**SEDIMENT INVESTIGATION WORK PLAN ADDENDUM**
**FORMER MIRRO PLANT NO. 20 SITE**
**44 WALNUT STREET, CHILTON, WISCONSIN**
**BRRTS NOS. 02-08-520157 (ERP) AND 06-08-426946 (VPLE)**

December 1, 2025

Figure 1 – Proposed Additional Sediment Sampling Locations

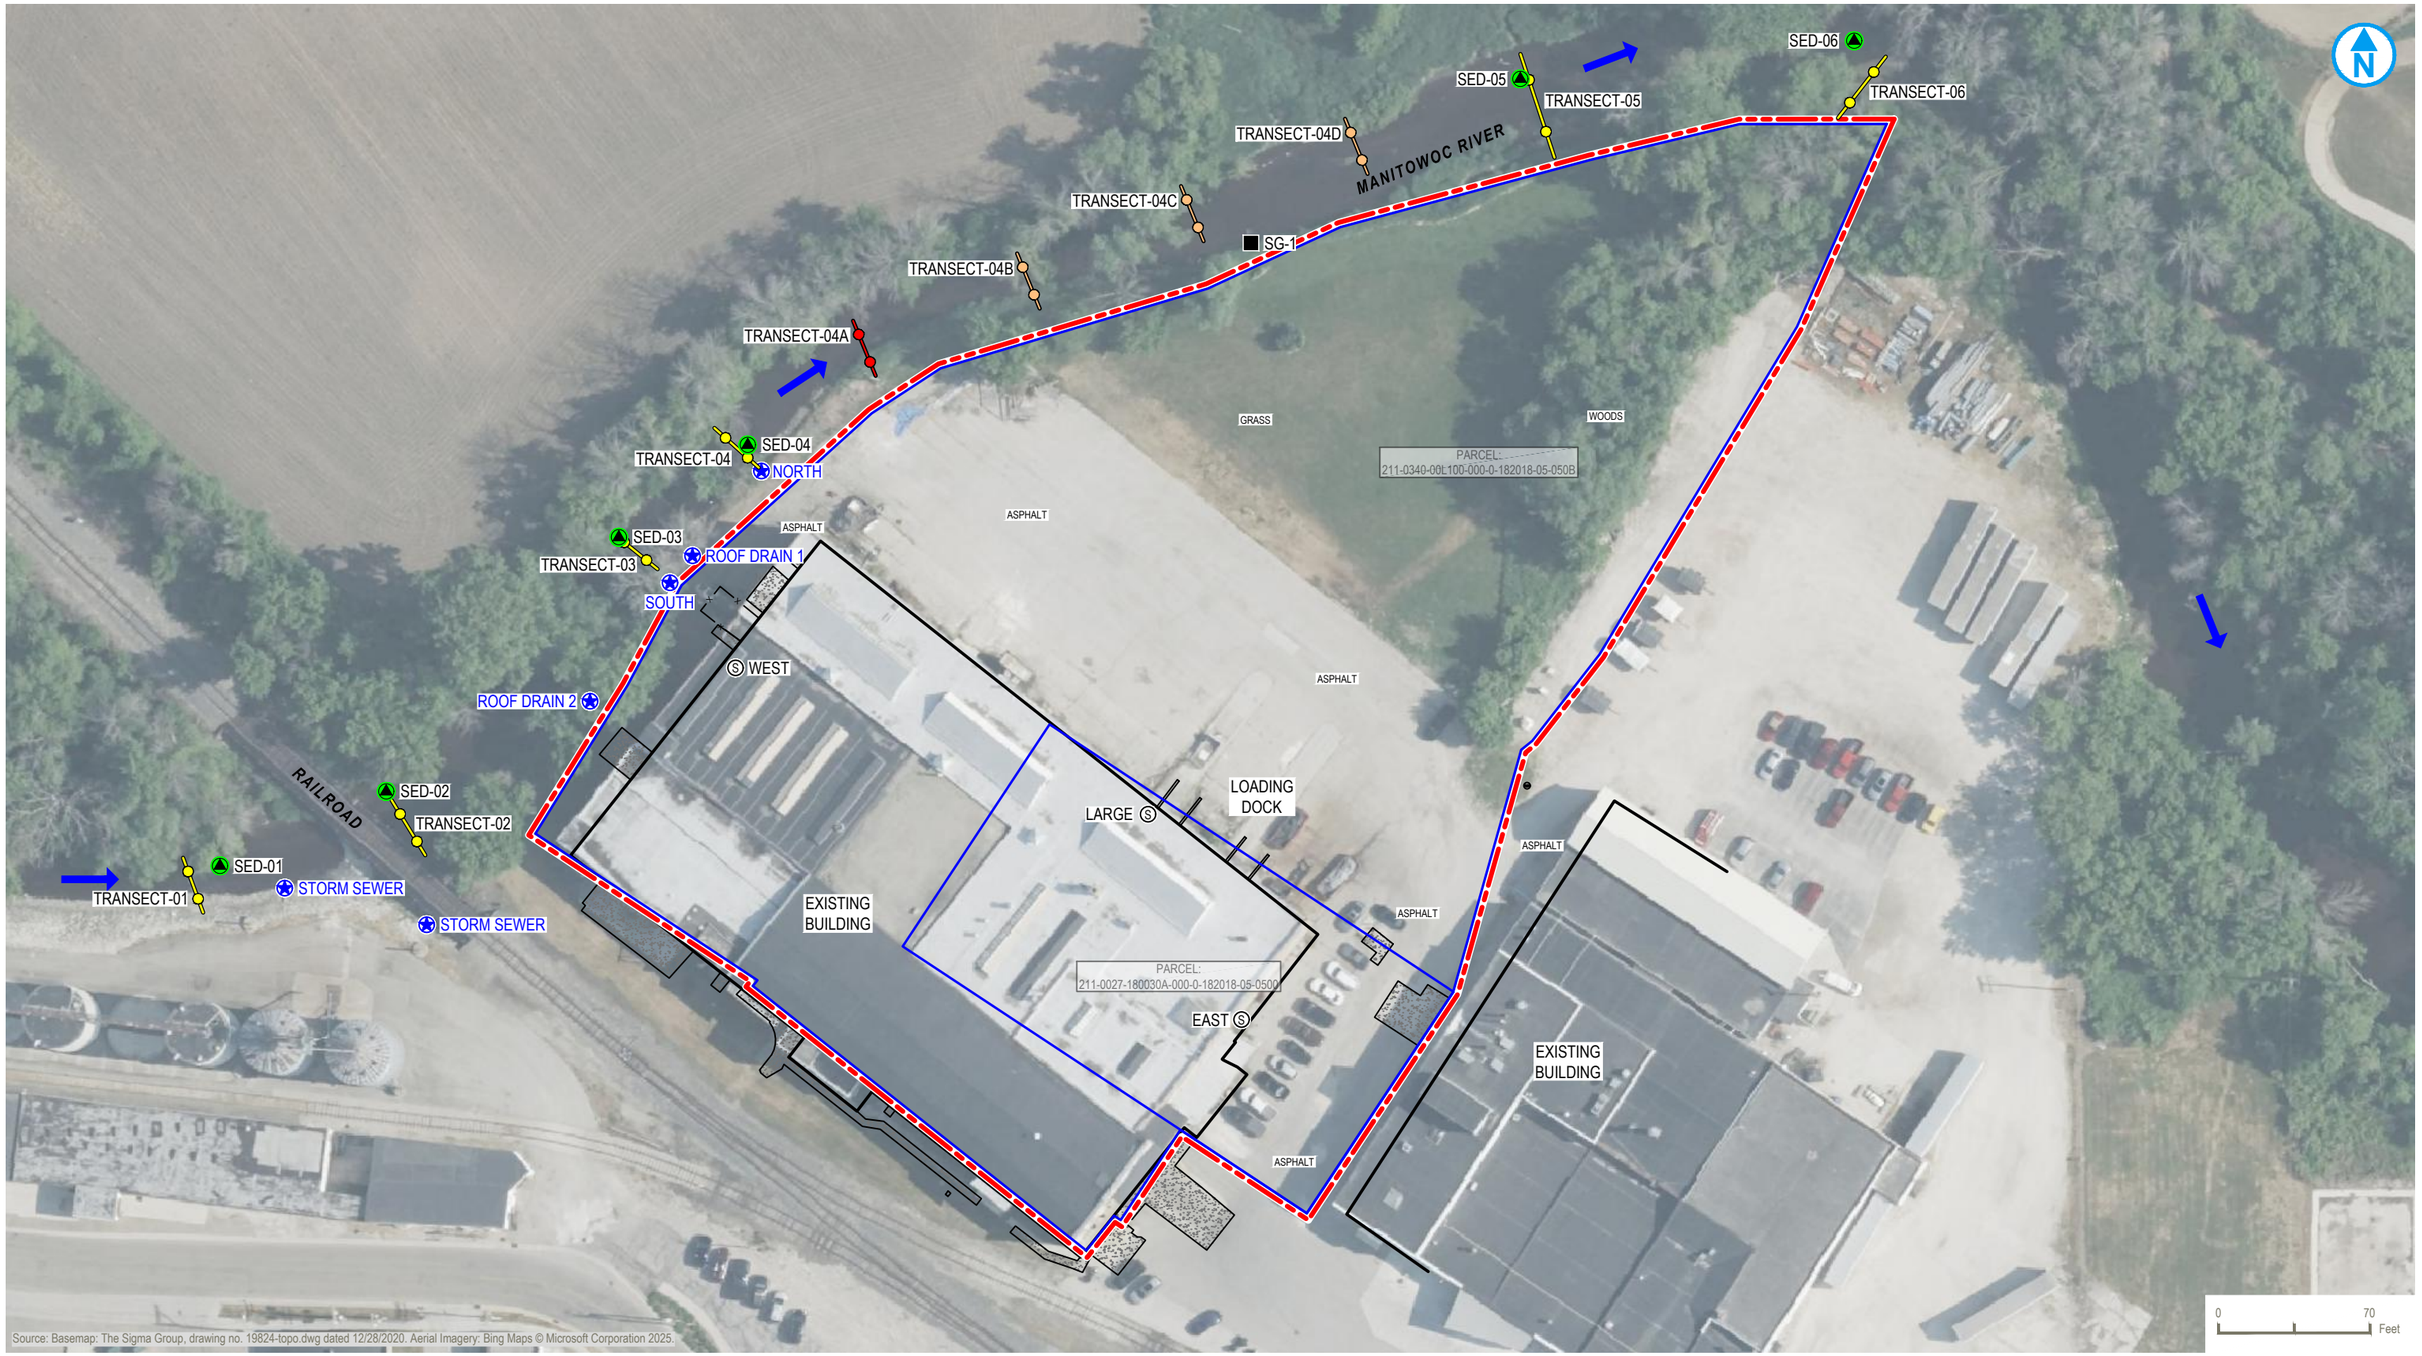
The following describes the proposed additional sampling activities. The sampling will be performed following the same procedures outlined in the May 2025 *Sediment Investigation Work Plan* as approved by the WDNR in their letter dated July 25, 2025. Proposed sample locations referenced herein are shown on the attached Figure 1.

- Visually inspect and check for the presence of soft sediment using a poling rod at two points along Transects 04A through 04D. The location of each transect point will be surveyed with a real time kinematic global positioning system (RTK-GPS). Sample locations may be adjusted in the field based on the observations made.

- Select one location along each transect for sample collection. The location with a greater accumulation of soft sediment/finer material present at each transect will be selected for collection of a discrete sediment sample.

- Submit one sediment sample (SED-04A) collected downstream of existing SED-04 location. The sample will be collected from the 0 to 0.25 feet below the top of sediment along Transect-04A and submitted to a Wisconsin-certified laboratory for total lead analysis.

- Collect three additional contingent sediment samples (SED-04B, SED-04C, and SED-04D) further downstream of SED-04A for potential analysis. All contingent sediment samples will be held at the laboratory. If SED-04A has a concentration

of total lead above the Consensus-Based Sediment Quality Guidelines (CBSQGs) Midpoint Effect Concentration (MEC), then SED-04B will be analyzed. This iterative process will be utilized to determine the need for subsequent sample analysis.
